AGENDA PLANNING COMMISSION MEETING

October 2, 2025 - 6:00 PM
City Hall Council Chambers

To: Planning Commission
From: Kris Jenson, Planning Manager
Date: September 23, 2025
Subject: Packet Material for the October 2, 2025 Planning Commission Meeting
Agenda Item: Taco Bell Conditional Use Permit
Action Deadline: October 19, 2025

To: Planning Commission
From: Kris Jenson, Planning Manager
Date: September 22, 2025
Subject: Packet Material for the October 2, 2025 Planning Commission Meeting
Agenda Item: Ritter Meadows amenity building conditional use permit

SITE PLAN

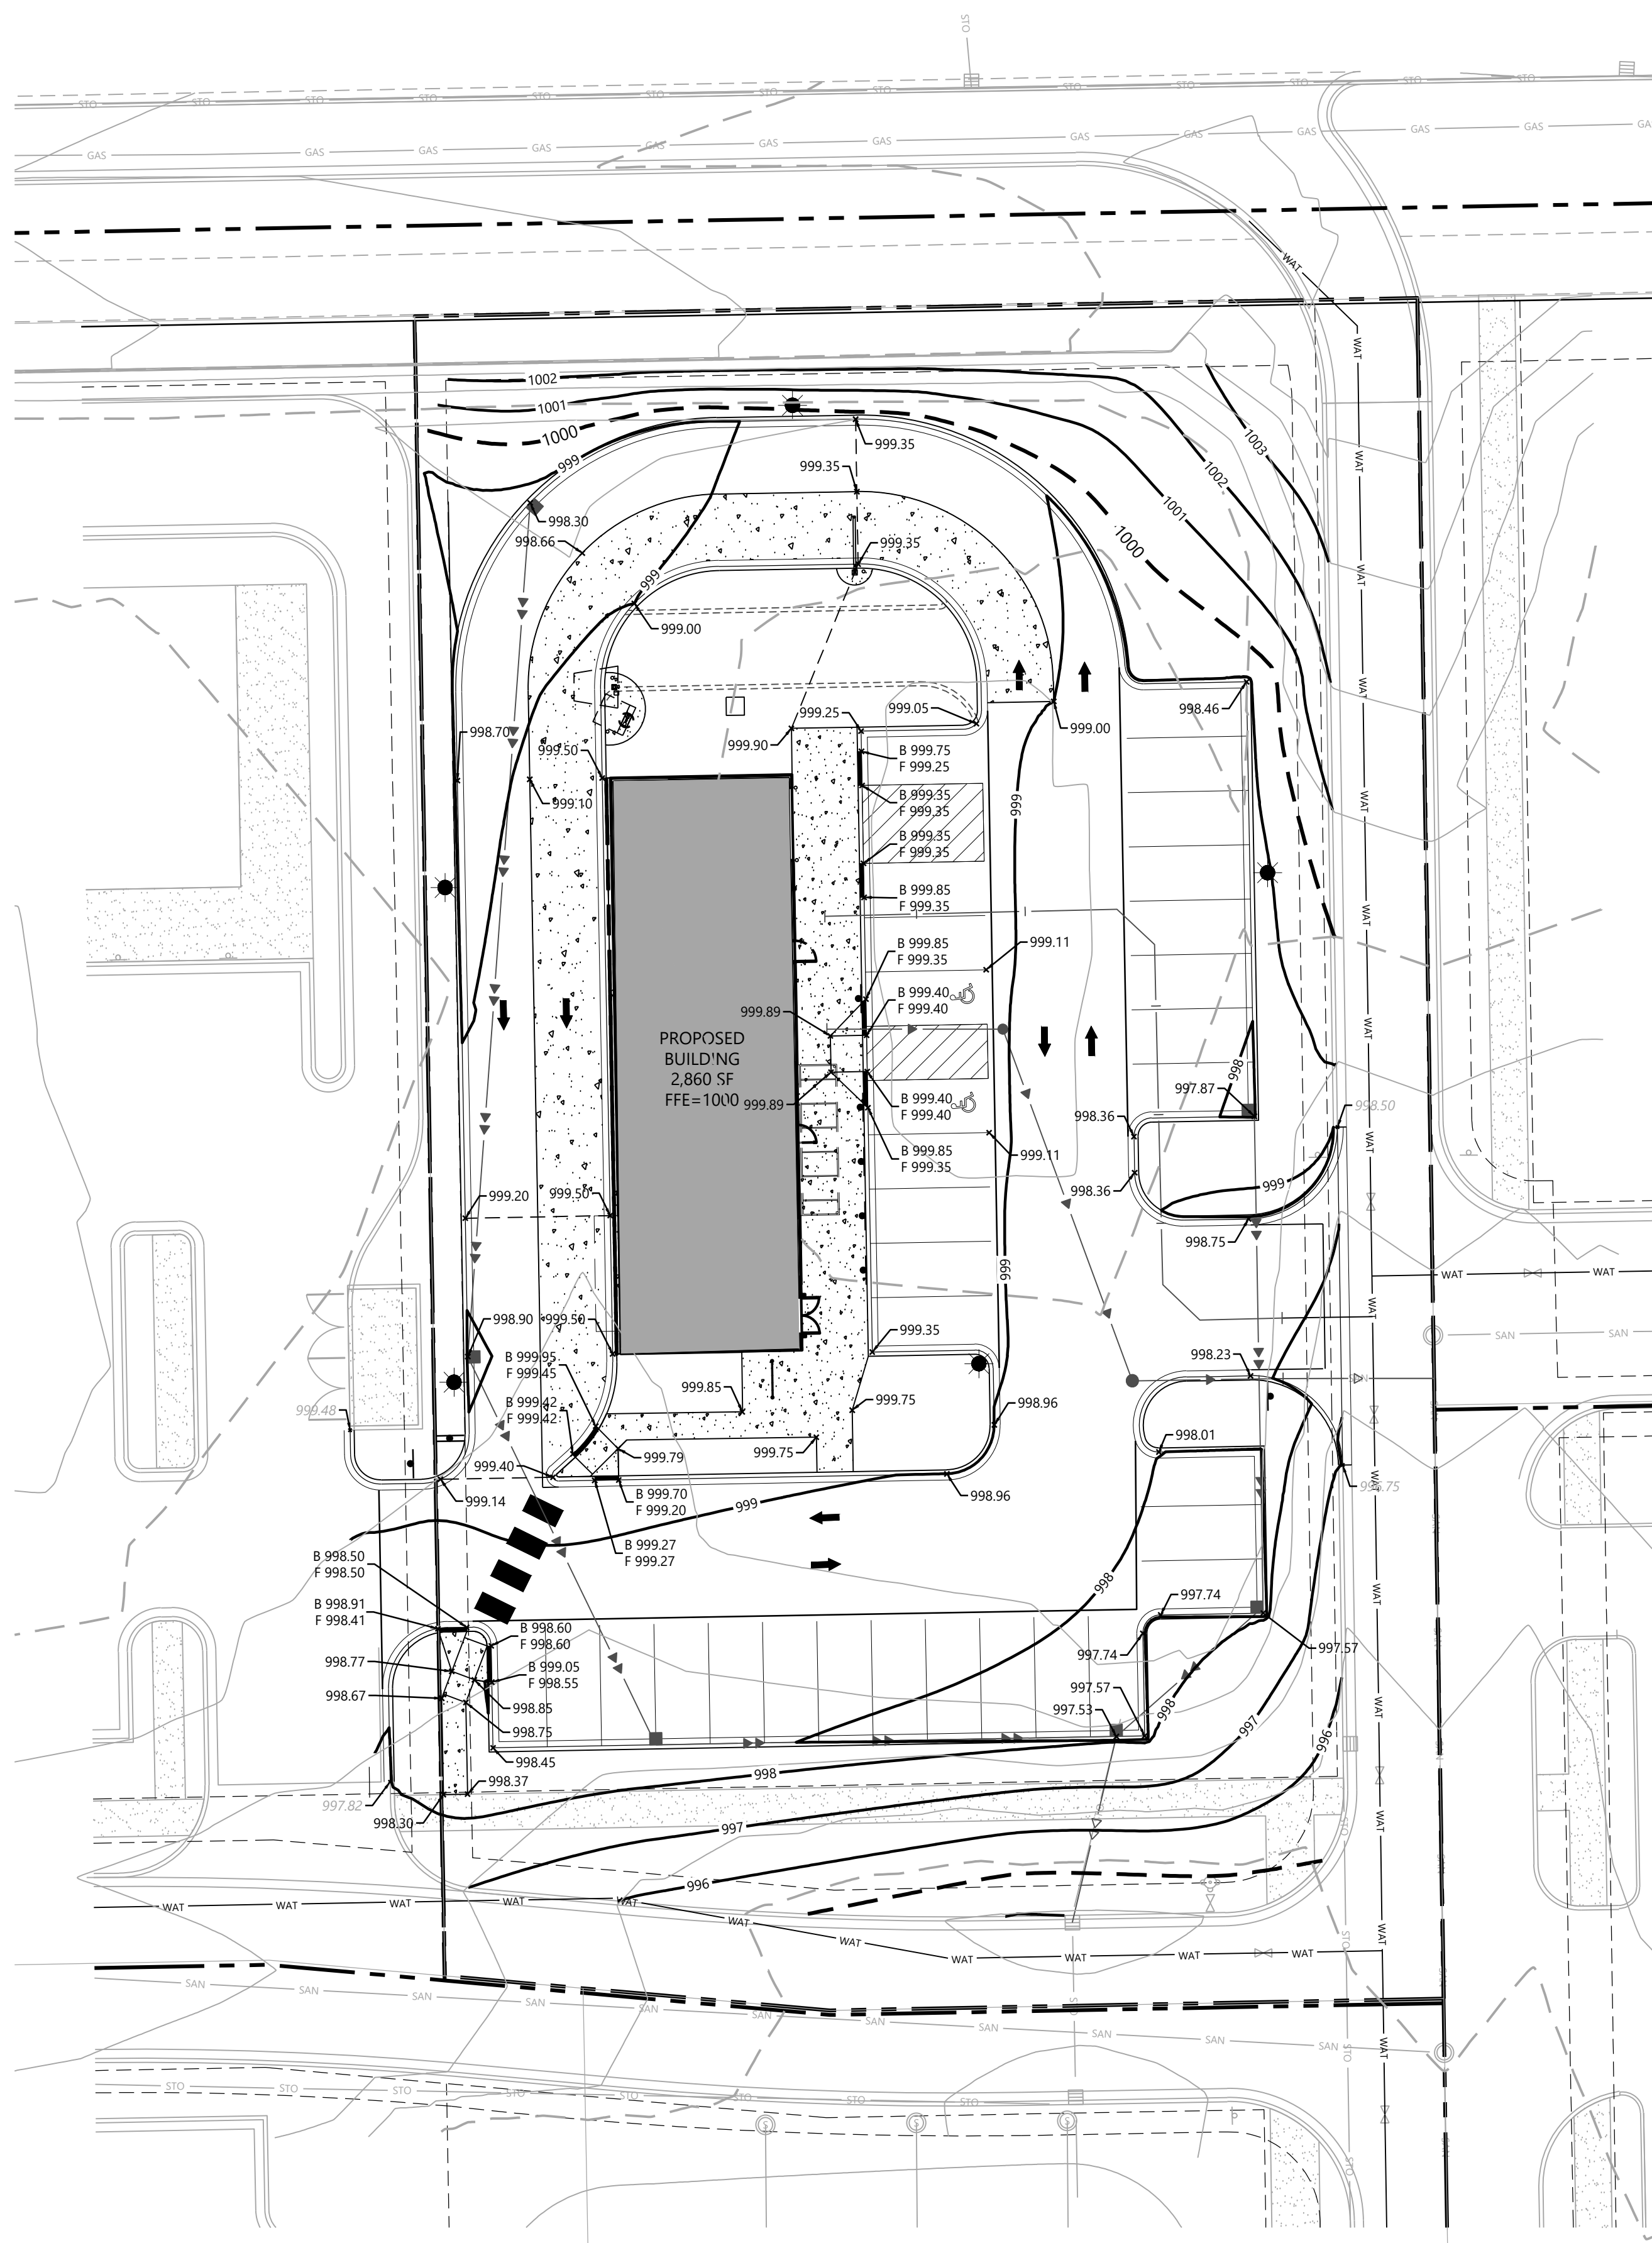
Mechanical Equipment. A transformer is indicated on the site plan at the rear (north side) of the building and is surrounded by landscaping. Any additional mechanical equipment that may be added to the site must be screened with landscaping (ground level) or by panels (rooftop).

LANDSCAPE
PLAN & NOTES

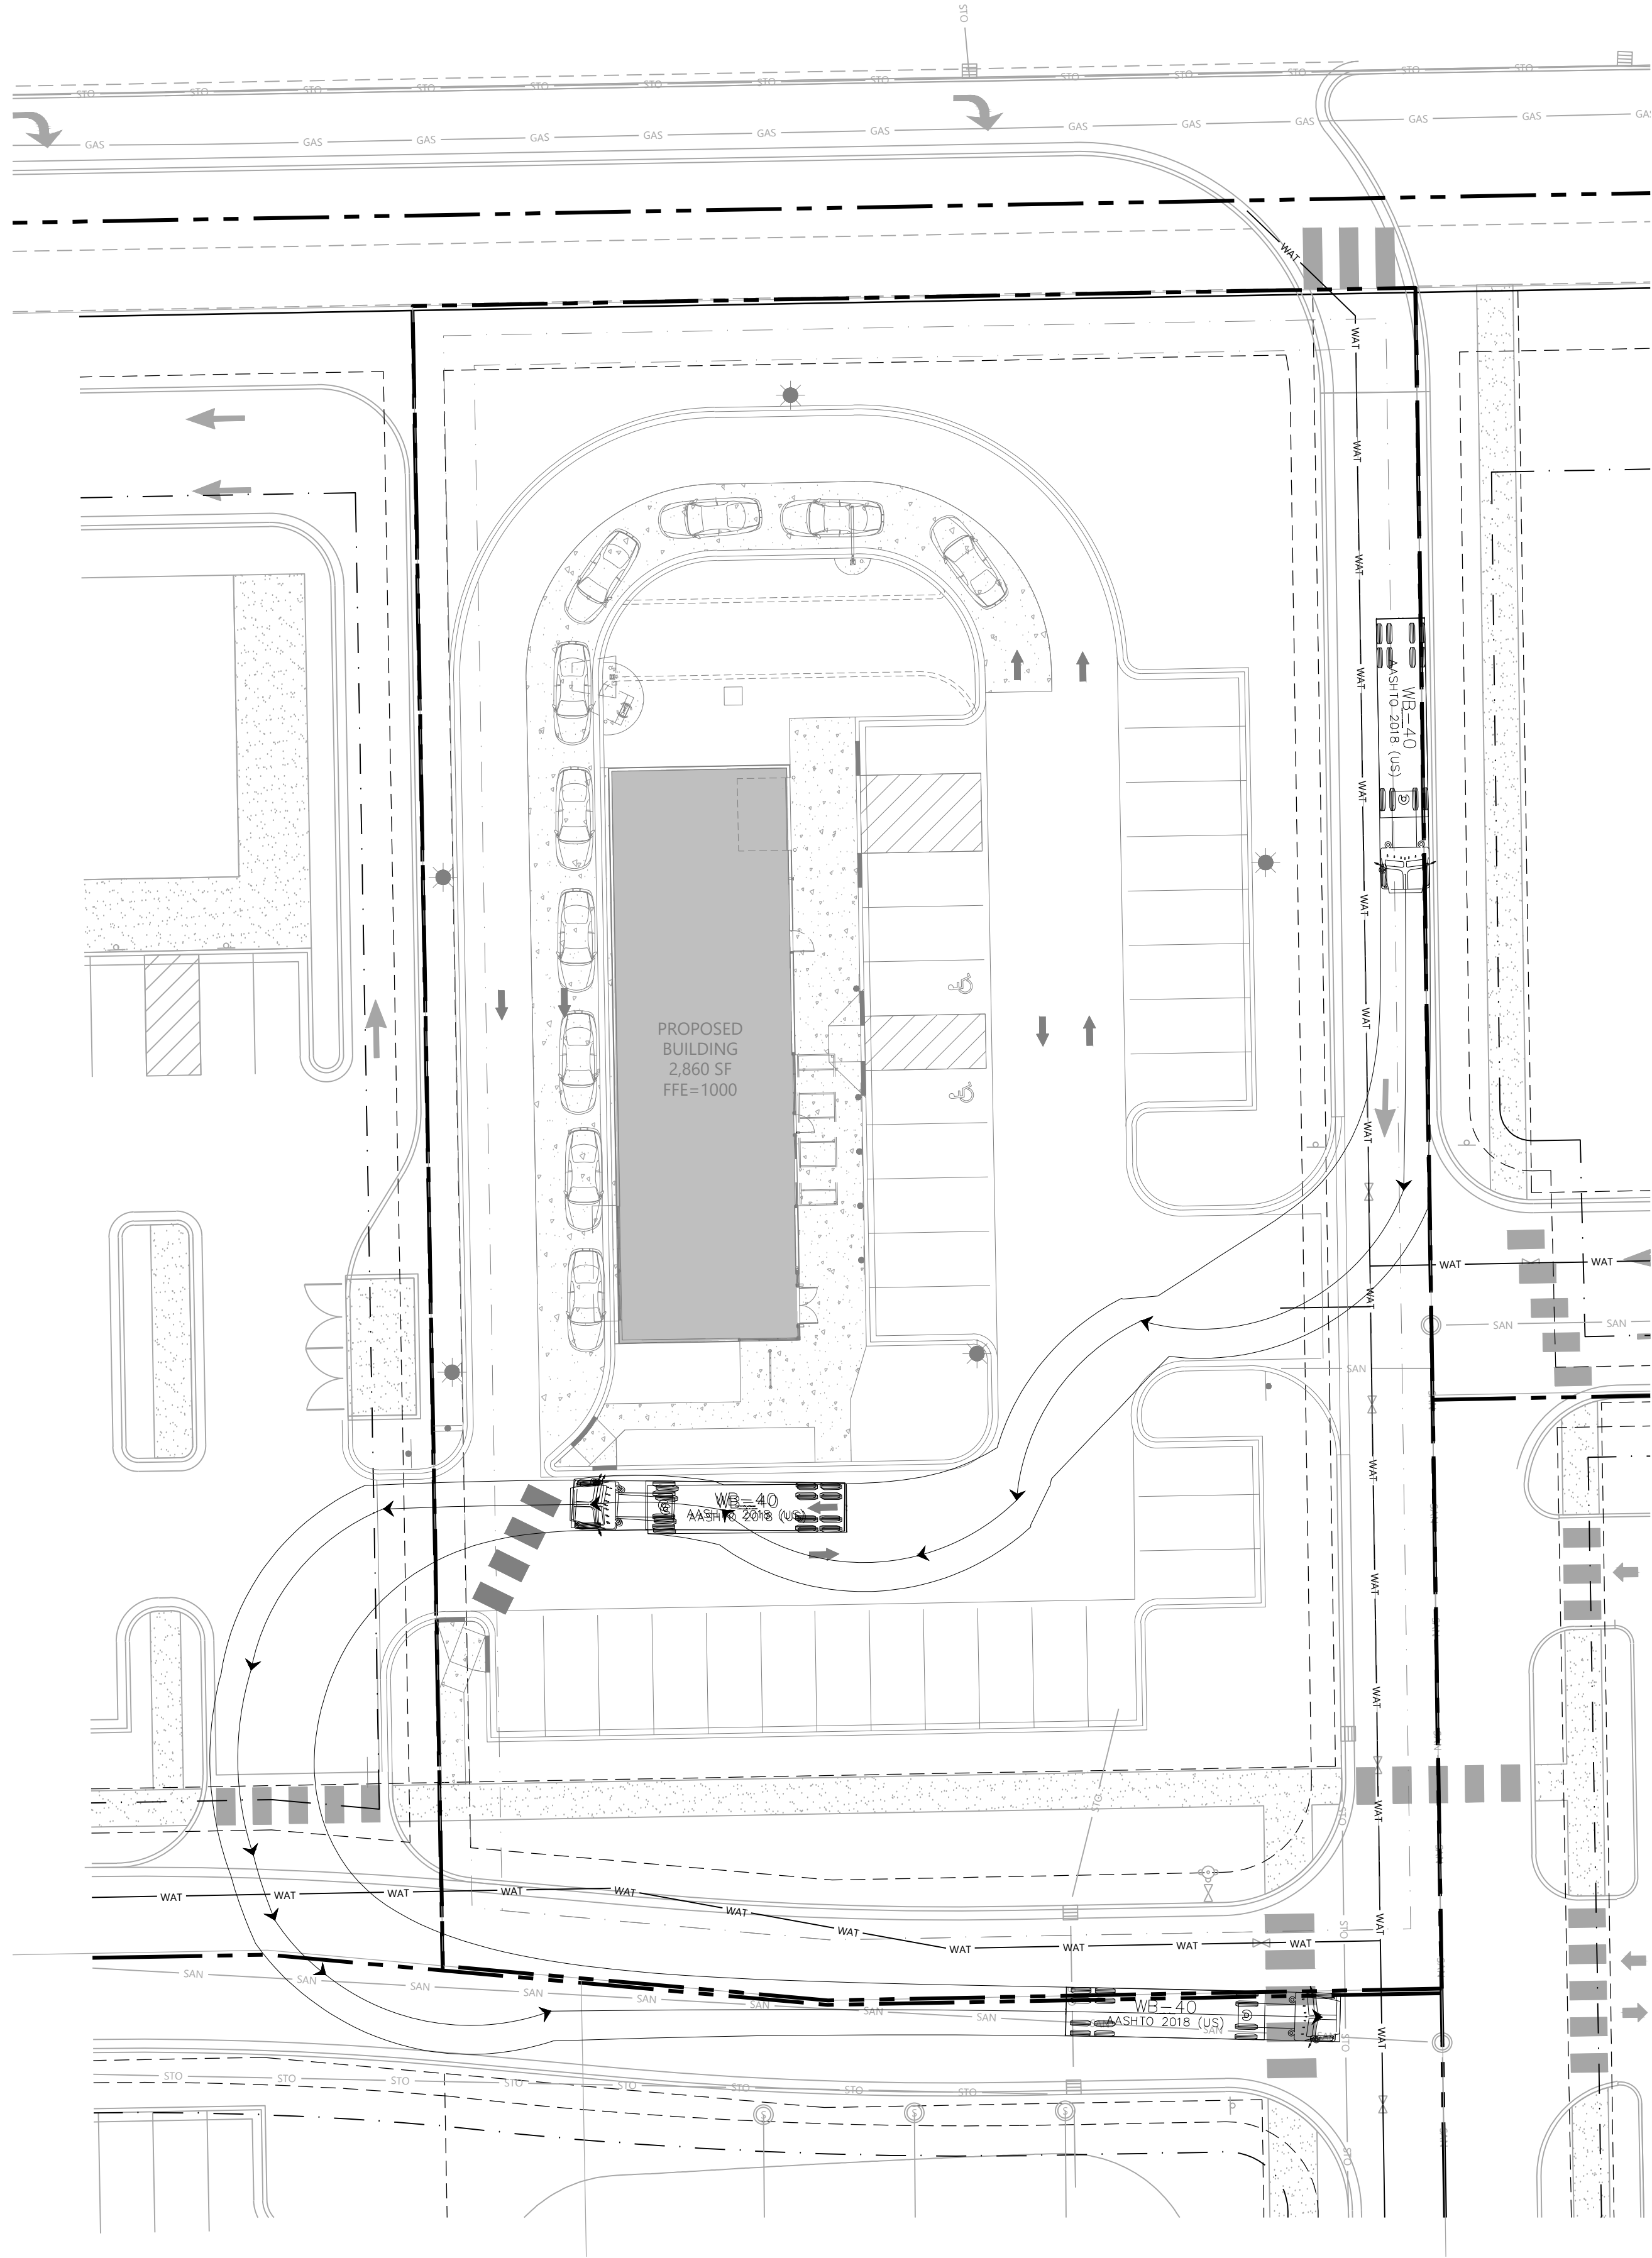
Landscaping. The landscape plan provides plantings on the north, east, and south sides of the site, including plantings along the east-side parking spaces to minimize headlights shining onto the entrance access drive. Sizes of proposed plantings comply with Section 11-21-9.C of the Zoning Ordinance. The City Forester reviewed the proposed landscape plan and provided comments. Evergreen shrubs must be added along a portion of the north property line to ensure that headlights from vehicles within the drive through line don't shine onto 179th Street and an additional overstory tree must be added along the south side of the site and the spacing adjusted to 40 feet apart. The landscape plan must be updated to reflect this change prior to City Council consideration of the CUP. Including the landscape modification, the landscape plan will be considered approved. Plantings on the site must adhere to the plan and provide a as-built landscape plan prior to inspection of the installed landscaping. An escrow for the landscape materials and installation amount will be collected with the building permit.

4. Prior to City Council consideration, the landscape plan must be updated to add evergreen shrubs along a portion of the north property line to ensure that headlights from vehicles within the drive through line don't shine onto 179th Street and an additional overstory tree must be added along the south side of the site and the spacing adjusted to 40 feet apart. Plantings on the site must adhere to the plan and an as-built landscape plan provided prior to inspection of the installed landscaping. An escrow shall be submitted with the building permit application to guarantee installation of the approved landscaping.

TRUCK MOVEMENT
SHEET NUMBER:
X100
DATE: 08/01/2025

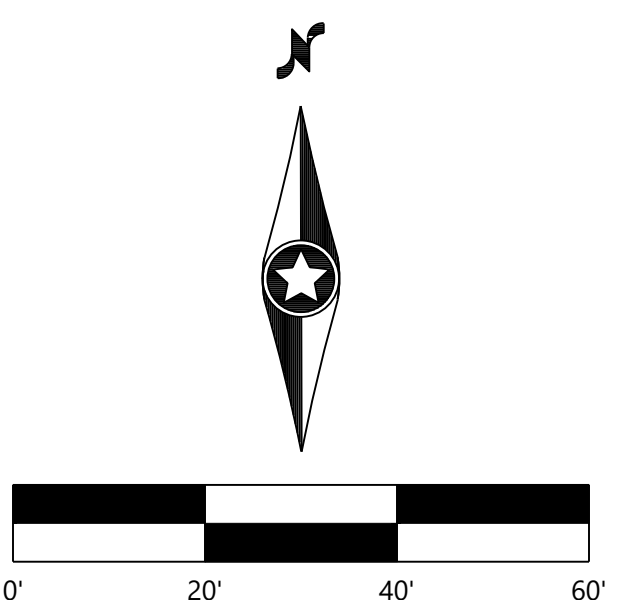
Circulation and Loading. Truck turning movements have been overlayed on the site plan to demonstrate that the site can accommodate larger delivery vehicles, who will enter from the east access and exit via the access at the southwest corner. Should the development of the parcel to the west of Taco Bell occur at a later time and therefore the connection to the east/west private drive not be available, the delivery trucks will be able to back up to the north, along the east side of the building, and exit via the east driveway in the interim.
